## **Application 2220163-RMACOM - Response to Request for Further Information dated 18 October 2022**

- 1.3 On 18 October 2022, Far North District Council (**Council**) made a request for further information in relation the Application (**Request**).
- 1.4 We have summarised each item in the request in italics, and provide a response to each item in the Request below.

TITLE  
**SCHEME PLAN**  
 BEING A SUBDIVISION OF  
 PT LOT 1 DP 67692 & LOT 6 DP 417562  
 STAGES 3 & 4

- 100 RESIDENTIAL LOTS (1-100)
- ROADS TO VEST (ROADS 3-5)
- JOALS 101, 102 & 103

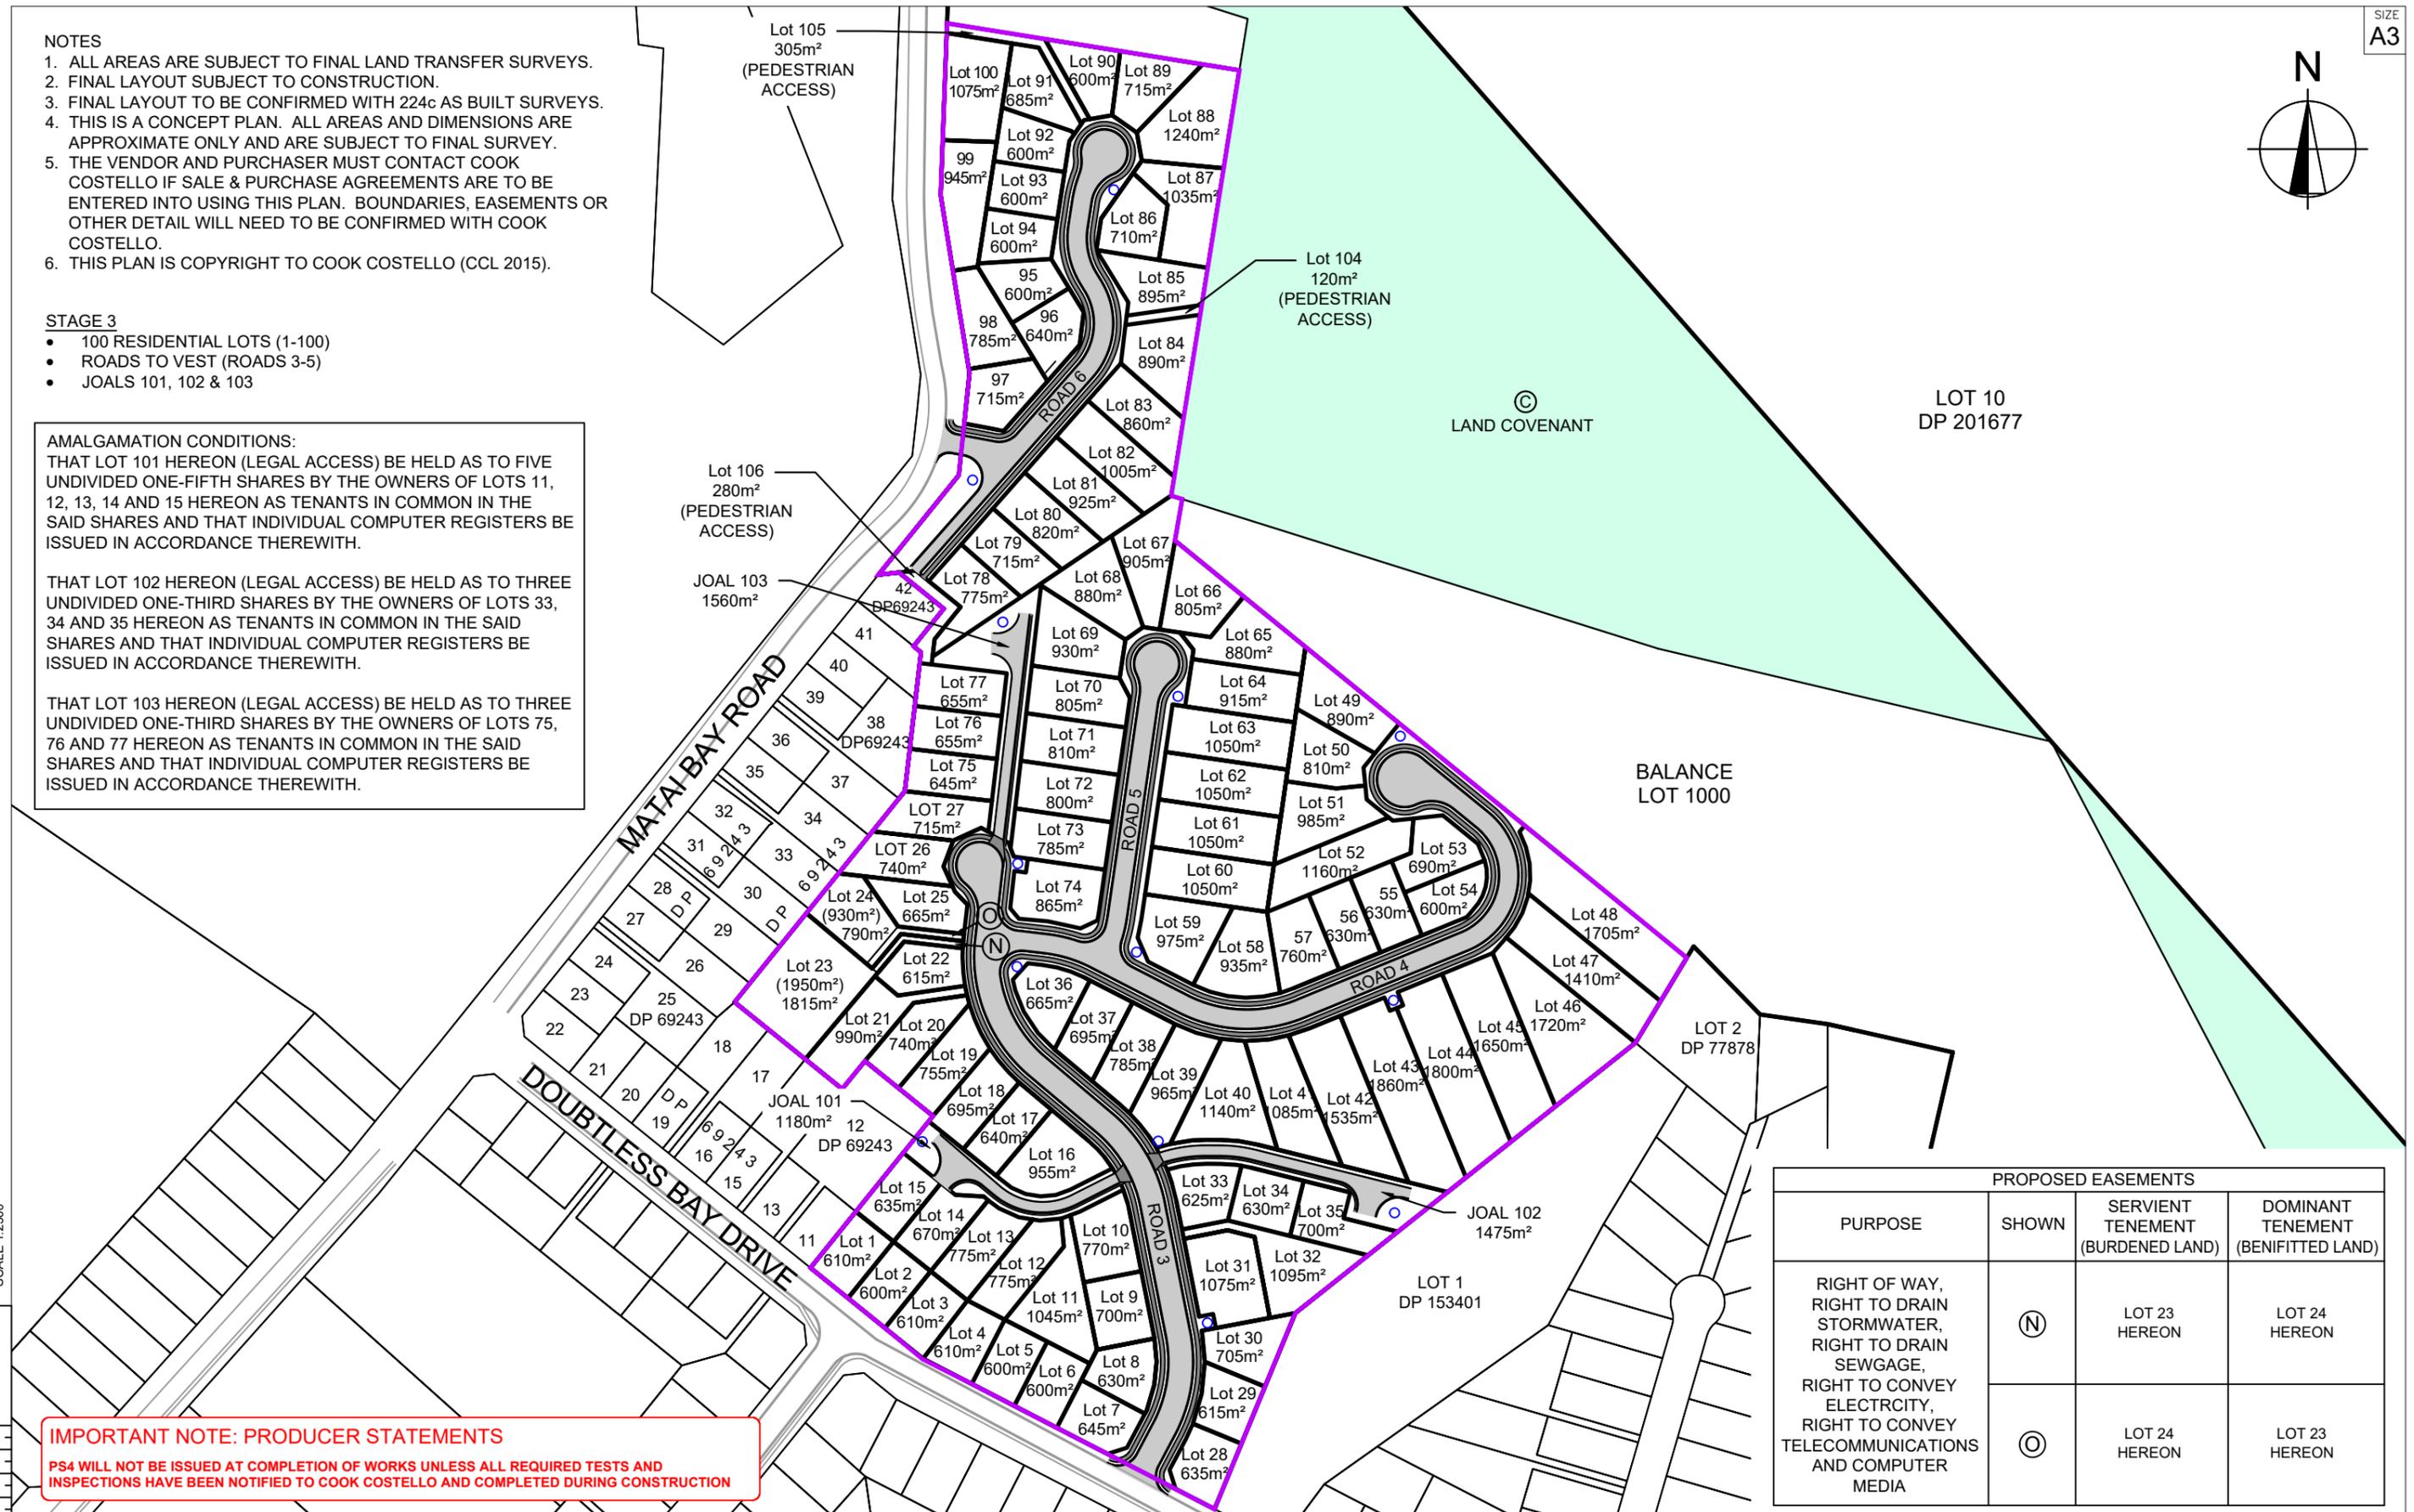
- 6.1 *Documentation supplied (Draft 2021 Scheme Plan Von Sturmers) for stages 3 & 4 show that Lot sizes are less than the required 600m<sup>2</sup> minimum size for Residential zoned sewerred sites (at a glance Lots 57, 96, 97, 99, 100 etc). The subdivision does not appear to meet zone standards as a controlled activity (13.7.2.1(v)).*

- 6.2 *Please confirm whether management plan subdivision is intended, and if so supply the management plan. Please supply all information necessary to complete the required assessment under section 13.10 of the Operative FNDP.*

- 6.3 Attached as **Appendix B** are revised scheme plans which identify that all lot sizes are 600m<sup>2</sup> or greater and therefore comply with standards of a controlled activity.

- 6.4 As a result of the revisions to the scheme plans, there have been amendments to the boundaries of the allotments. The outcome is that there is a minor decrease in the total number of lots. The revised plans provide for 38 lots in stage 3 and 100 lots in stage 4, which is two less lots than the scheme plans filed with the Application, which provided for 36 lots in stage 3 and 104 lots in stage 4.

- 6.5 We note the revised scheme plans show where some roads have been narrowed and are now proposed to be jointly owned access lots to minimise earthworks and improve the development layout.

- 16.4 *What is considered the optimum size for lots in stage 4?*
- 16.5 The revised scheme plan attached to this letter shows the appropriate size for lots in stage 4 of the proposed subdivision. The proposed lots all have an area greater than 600m<sup>2</sup>, and allow for a 14m x 14m square with a 3m setback from the road boundary and 1.5m side yards.

TITLE  
**STAGE 3**  
**FIRE FIGHTING PLAN**  
**OPTION 2**

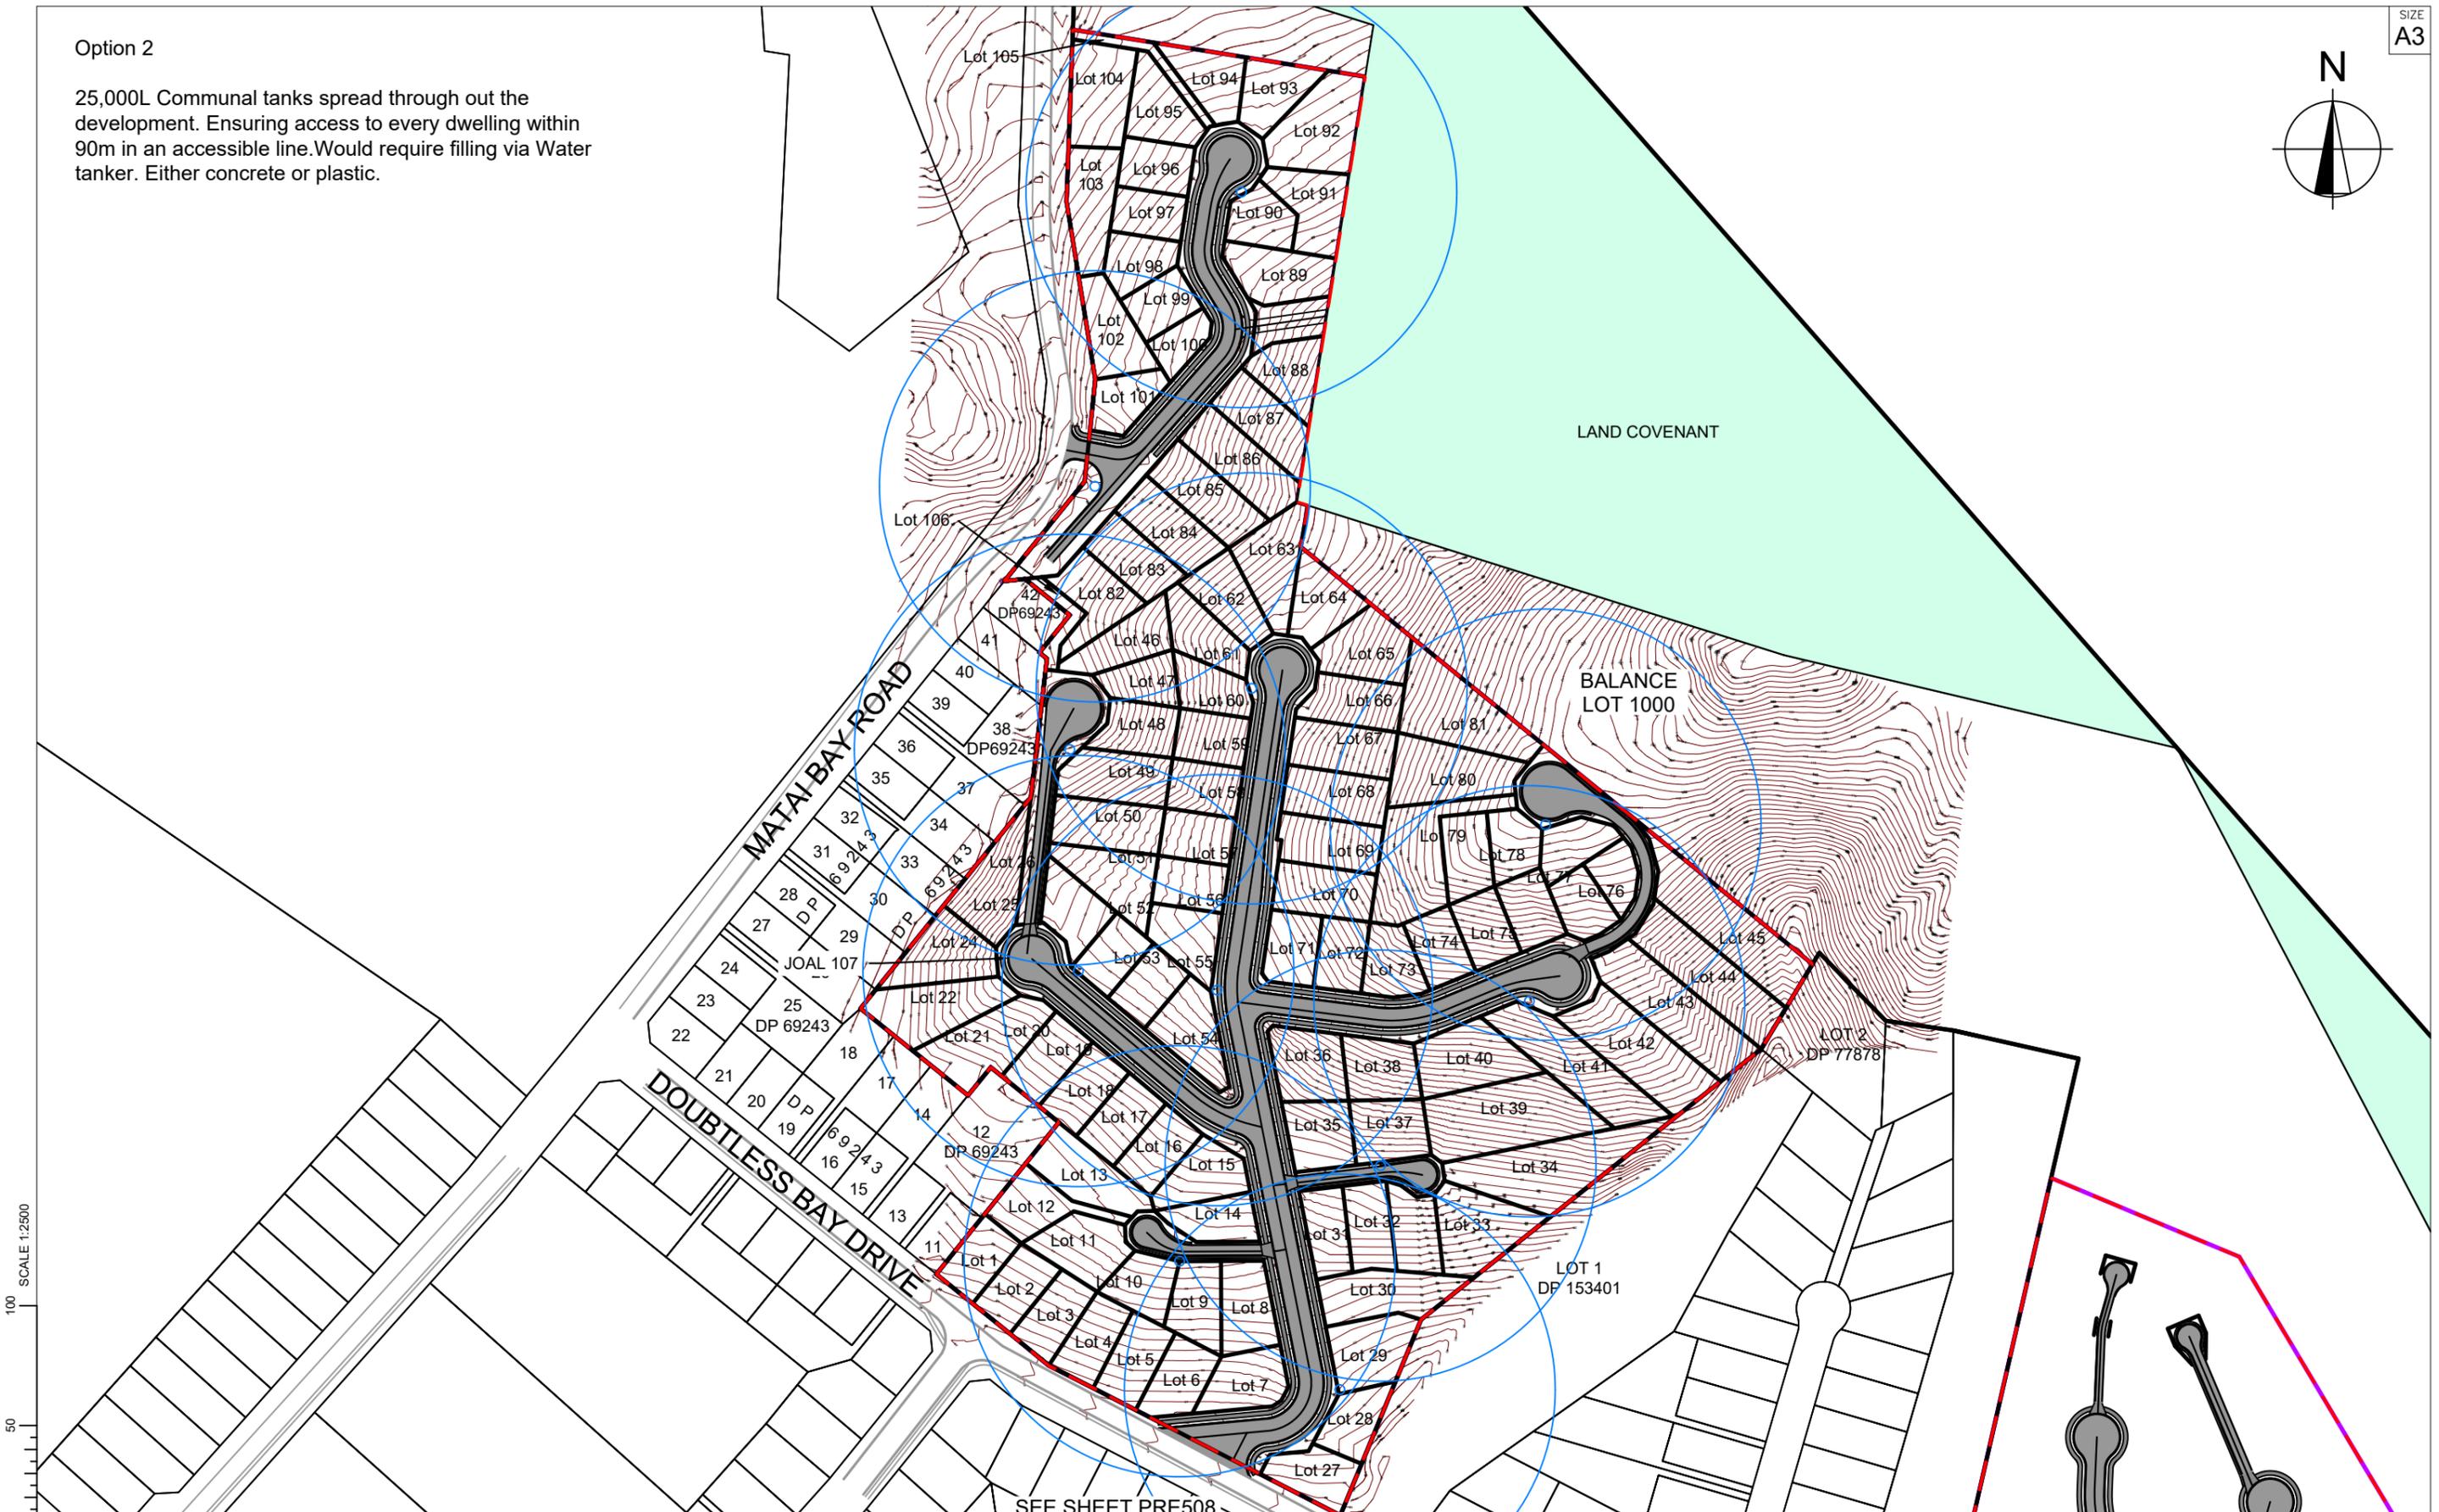
- 17.1 *Please supply a preliminary management plan that outlines the following:*
- (a) *Location, accessibility and reach of proposed tanks for firefighting,*
  - (b) *Details the proposed strategic/management approach to accessing water for firefighting within the subdivision, including the replenishment and maintenance of the tanks and associated pipework.*
  - (c) *Assessment of the accessibility by fire services to all allotments especially where road gradients prove prohibitive to service vehicles.*
- 17.2 Carrington's engineers, Cook Costello, are working with Fire Emergency New Zealand (**FENZ**) to provide appropriate measures for water for firefighting at the Site, and have agreed on initial options.
- 17.3 Please find attached correspondence with FENZ attached as **Appendix F**.

The second option is to install communal development firefighting water supplies. This option would involve installing 25-50 m<sup>3</sup> of firefighting water storage within 90 m of every dwelling. The volume quantity will need to be approved by FENZ.

Please see the development mark ups for the proposed locations of the communal firefighting water supply tanks. The location of the tanks is subject to change as the development progresses. The mark up shows two zones. One zone is 90 m from a tank in all directions showing coverage. The second zone is 90 m from a tank accessible via the proposed roads.

25,000L Communal tanks spread through out the development. Ensuring access to every dwelling within 90m in an accessible line. Would require filling via Water tanker. Either concrete or plastic.
